PLANNING REPORT

Architectural Review Board

48 S. High Street 24-130MPR

Address	48 S. High Street
Proposal	Façade modifications to a Landmark Building on a 0.25-acre site.
Request	Review and approval of Minor Project Review (MPR) under the provisions of Zoning Code Section 153.176
Zoning	HD-HS, Historic South District
Planning Recommendation	<u>Approval of Waiver.</u> <u>Approval of Minor Project Review with Conditions.</u>
Next Steps	Upon approval of the Minor Project Review, the applicant may apply for building permits through Building Standards.
Applicant	Robert Deuberry, Providential Properties LLC
Case Manager	Rati Singh, Assoc. AIA, Planner I (614) 410-4533 rsingh@dublin.oh.us

Proposed Façade Improvements

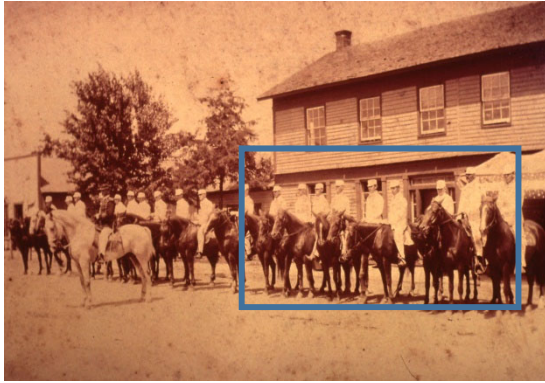
The applicant plans to install awnings above both the door and the storefront window. Currently, there is an awning on the façade above the existing doorway, as shown in the street view photo above. The applicant plans to adjust the location of this awning and intends to install all three awnings at the same height, ensuring that the bottoms of all the awnings align.

Per Code, awnings may be used if they function as a suitable protection from the elements and may encroach the sidewalk. Code requires the lowest portion of the awning to be at least eight feet above the sidewalk and the awning to be mounted inside the window/door frame. The existing door awning is pre-existing and does not meet either Code requirement.

Regarding awning height, the applicant proposes that the three new awnings match the height of the existing awnings at 50 S. High Street. This would create a clear height of 6' 8" inches above the sidewalk, maintaining architectural appropriateness and cohesiveness among the awnings across the entire building's frontage. This will require a Waiver, herein. Since signage on awnings is required to be at least 8' above the sidewalk, per Code Table 153.173L, staff recommends a clarifying condition of approval, that signs are not permitted on these awnings.

Regarding awning placement, Code requires that awnings be located inside the window/door frame (as shown above in red dotted lines). The applicant shall ensure that the awnings comply with the Code and provide this information at the time of building permit per a recommended condition of approval.

The applicant proposes cedar shake siding above the doors and window below the head trim. Staff recommends smooth MDF panel, painted to match the trim color and staff recommends a condition of approval to address this. Applicant proposes to paint the existing siding in Benjamin Moore White Dove OC-17, matching the existing color of the building, where required.

- 1) The applicant adjusts the location of the existing awning to ensure that all three awnings are installed at the same height and with the same clearance above the sidewalk and provide this information prior to Building Permit.
- 2) The applicant ensures that awnings are placed within the side wood pilasters and provides information prior to Building Permit.
- 3) The applicant provides fiberboard panel above the door and window instead of wood shakes, painted to match the color of the trim and provides information prior to Building Permit.
- 4) The applicant provides awning sample for staff review prior to Building Permit.
- 5) The applicant ensure that no signs will be proposed on the awnings with any future sign application.
